Central Planning Authority

Agenda for a meeting of the Central Planning Authority to be held on **August 16, 2023 at 10:00am in Conference Room 1038, 1st Floor, Government Administration Building, and Elgin Avenue.**

CPA/17/23

Proposed Section 26

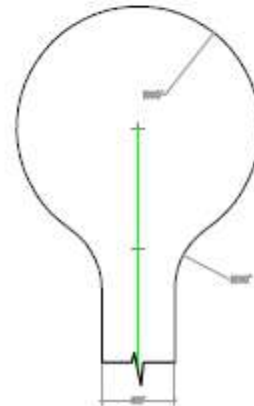
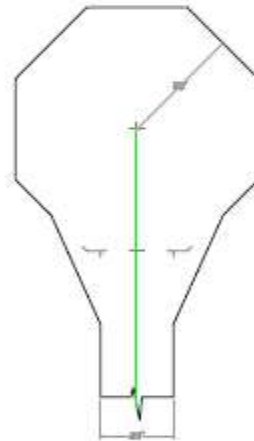
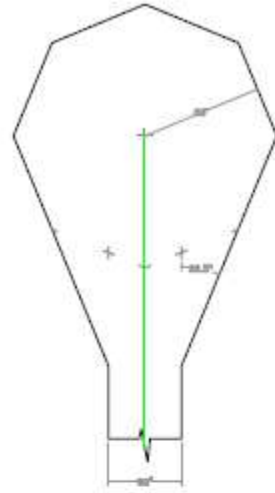
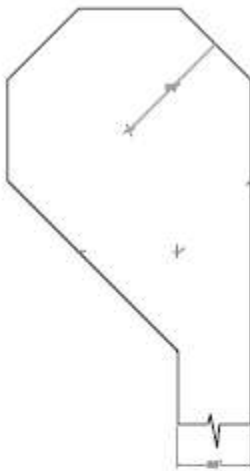
The proposed section 26, as shown in the below schematic, is designed to come across the above block and parcel (25C146), utilizing the existing road parcel. Therefore, the proposed access will need to be built to NRA specifications.

Figure 1: Land cover map overlaid on proposed site plan, note the majority of the site is covered by tidally flooded mangrove forest and woodland (Source: DoE, 2023)

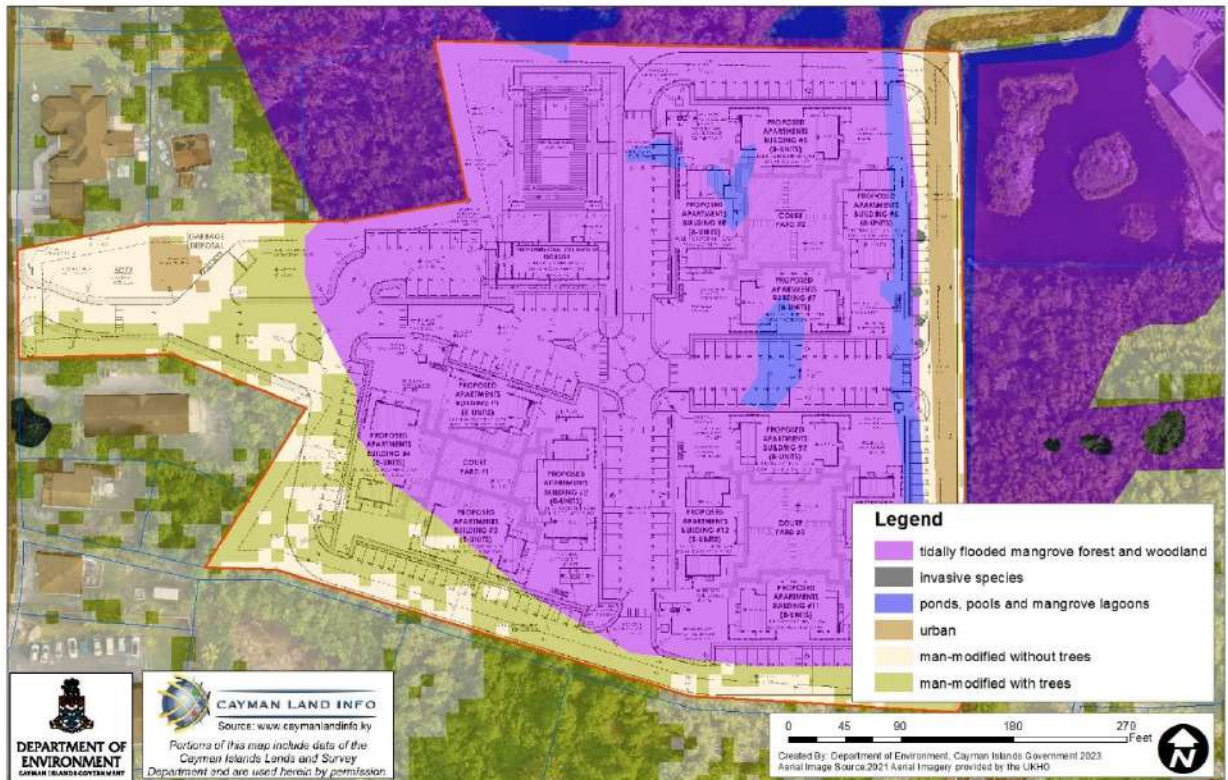
The application site consists primarily of tidally flooded mangrove forest and woodland (refer to Figure 1) and features several ponds or pools.

Figure 2: Site contours overlaid on 2018 aerial imagery (Source: LIS, 2018)

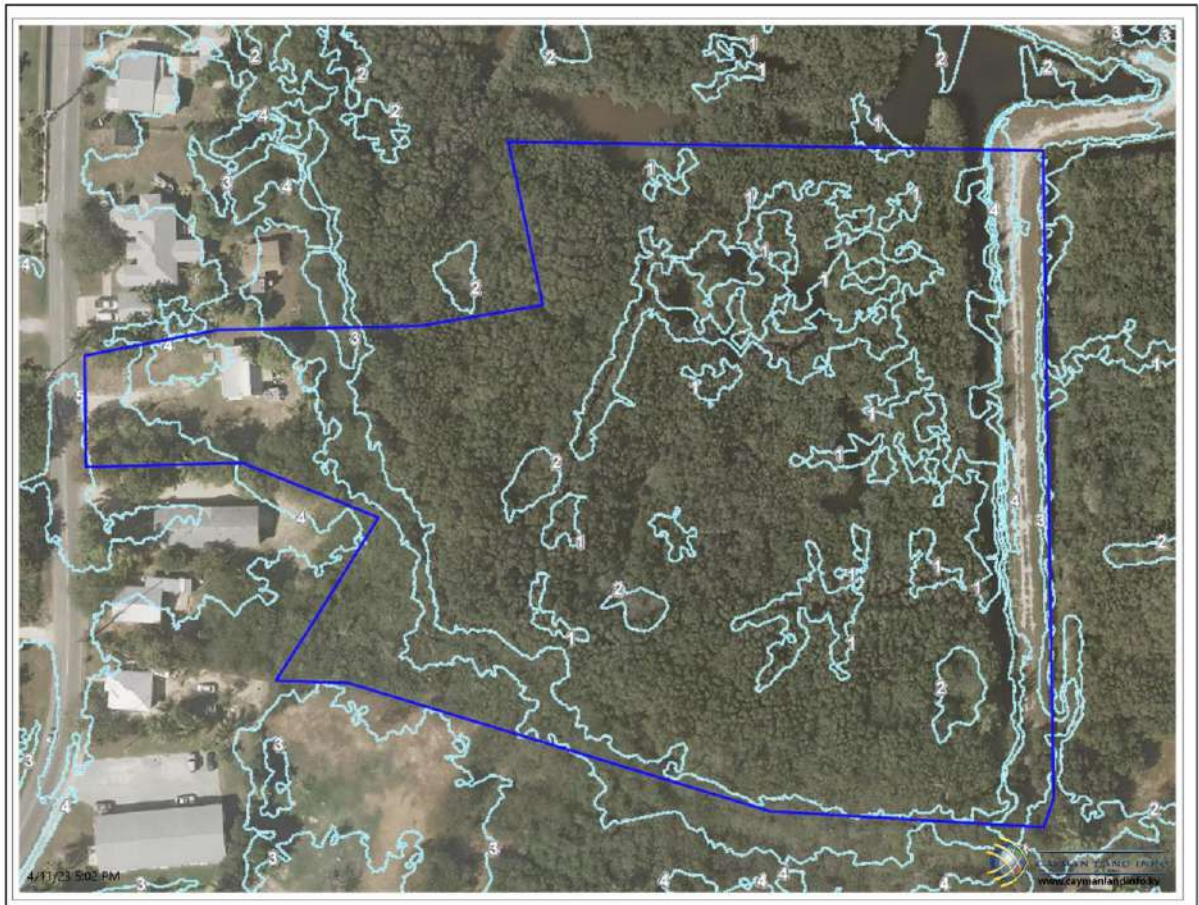
The site is very low lying, averaging around 1 foot above Mean Sea Level (refer to Figure 2). As such, drainage is likely to be a significant concern. The proposed site plan also features a large amount of hardscaping. We recommend that the applicant considers the use of porous or permeable paved surfaces in areas of hard standing such as the driveways and parking areas. The low elevation of the site should be considered during the production of a storm water management plan. The level of the site relative to the water table is likely to mean that commonly used drainage systems such as catch basins and deep wells are likely to be much less effective. The proposed site plan features a number of courtyard areas which could be used to incorporate sustainable urban drainage systems (SUDS) such as detention basins or retention ponds. This would not only improve the drainage of the site, but also the surrounding area.

Figure 2. LIS 2018 Aerial Imagery showing the Application Site outlined in red

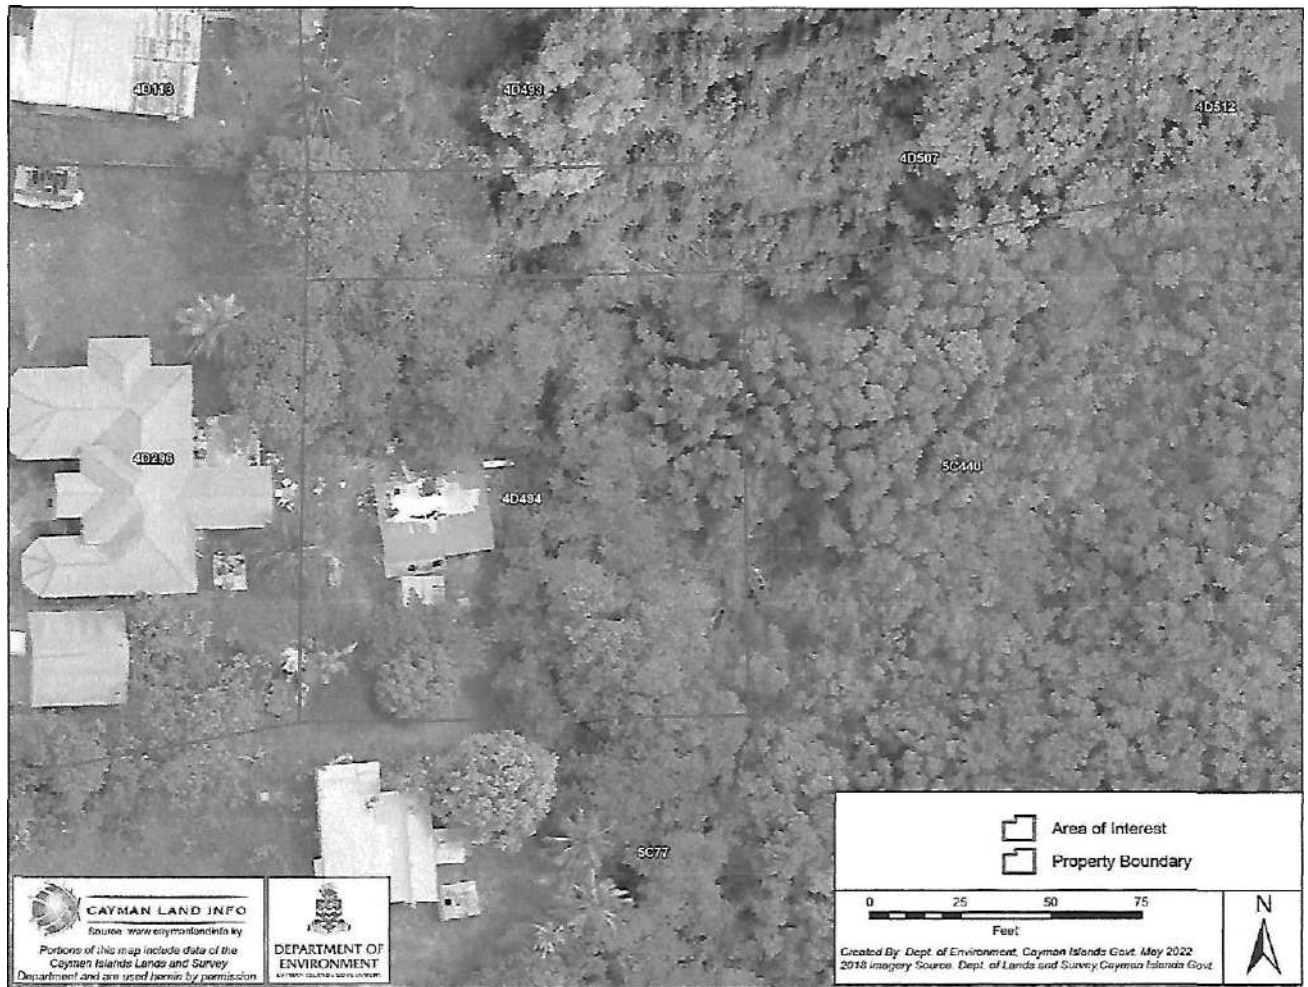
Justification for the land clearing has not been included in the applicant's submissions, therefore, the DoE considers the proposal to be speculative clearing. The DoE does not support speculative clearing of parcels prior to planning permission for development being granted. We recommend that applications for land clearing are presented along with the development proposal so that appropriate mitigation measures can be recommended, as there may be varying recommendations depending on the form and nature of the development being proposed. Once planning permission has been received, the DoE encourages applicants not to undertake land clearing until development is imminent to allow ecosystem services to continue to function until they are ready to begin construction.

However, it is noted that that there is any existing structure on site as shown in Figure 2 and that much of the site is man-modified with regrowth around the existing structure. Without a rationale for the clearing we would encourage applicants to retain as much native vegetation as possible to incorporate into the landscaping scheme. We particularly encourage the applicant to retain the

Figure 1: Aerial image showing the subject parcel in relation to the Salina Reserve and Colliers Wilderness Reserve. Base imagery source: Lands & Survey 2018 aerial imagery.

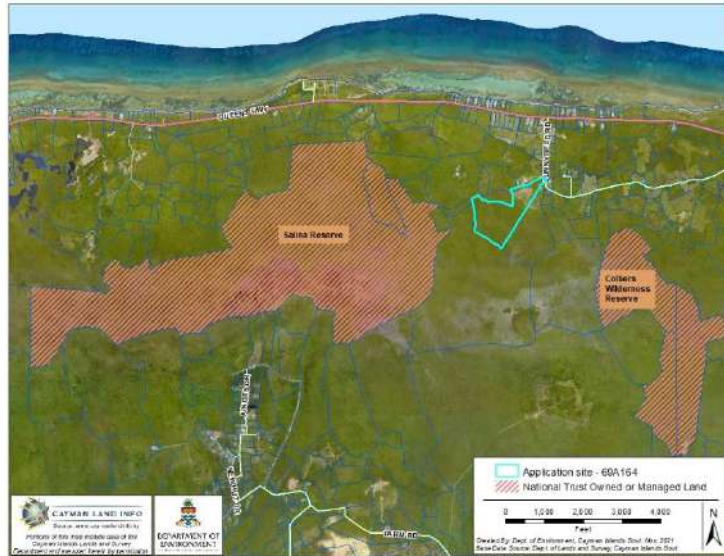
*The subject parcel and surrounding area currently serve as a wildlife corridor connecting two extremely important conservation areas: the **Colliers Wilderness Reserve** and the **Salina Reserve**. Habitat loss and fragmentation are huge threats to our wildlife. Our native species have complex daily requirements that require them to travel safely from place to place, looking for nesting sites, food, water, a resting haven and shelter. With the increased urbanisation of the island, wildlife corridors are vital for the survival of our species. They bridge the gap between habitats which otherwise would be small and isolated and join them together. Linking core wildlife habitats helps to restore and preserve biodiversity, allowing movement between important habitats to maintain genetic diversity in wildlife populations. Without this, local extinctions can occur.*

*For these reasons, we do not support clearing beyond the already impacted area (see Figure 1). Heavy machinery can crush or bury iguanas and their nests. It is therefore crucial that **no mechanical clearing, excavation or filling takes place prior to DoE consultation**. Should minor clearing be required, mechanical clearing must not take place during the Blue Iguana nesting season (1 June – 30 September yearly) without DoE consultation.*

- 1. There shall be no land clearing, excavation, filling or development of the resultant subdivided parcels without planning permission for such works being granted.*
- 2. Hand-clearing should be minimal and not extend into the primary habitat.*
- 3. Any future development, clearing, filling or excavation of the resultant subdivided parcels shall be the subject of a separate consultation with the Central Planning Authority and National Conservation Council.*
